SUNDRY NOTICES AND REPORTS ON WELLS
**Do not use this form for proposals to drill or to re-enter an
abandoned well. Use Form 3160-3 (APD) for such proposals.**

8. Well Name and No. **Bowers "A" Federal #44**

Texland Petroleum-Hobbs propose to TA the above captioned well as follows:

Bowers A Federal #44

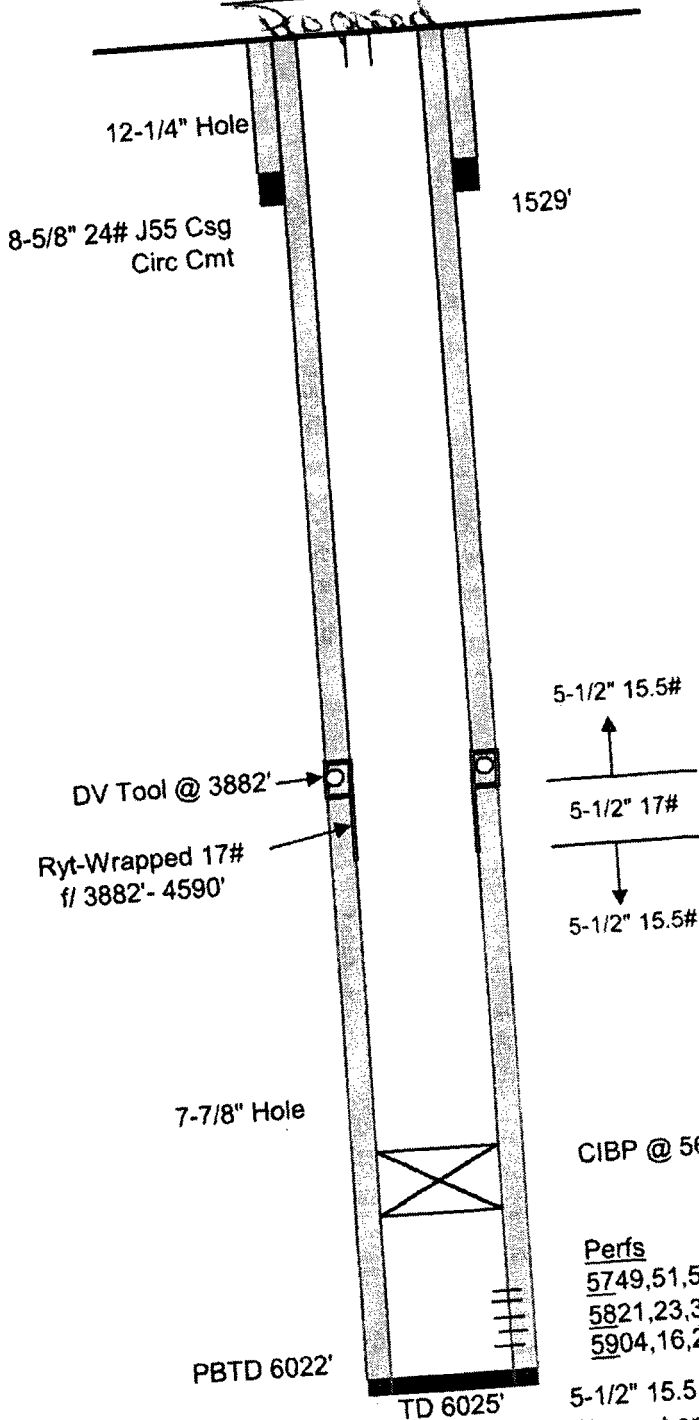
Set CIBP @ 5650' w/5 sks CI "C" cmt
Circ hole and pressure test to 500 psi for 30 min

Attached are the current and proposed Well Bore Schematics

**Condition of Approval: notify
OCD Hobbs office 24 hours
prior of running MIT Test & Chart**
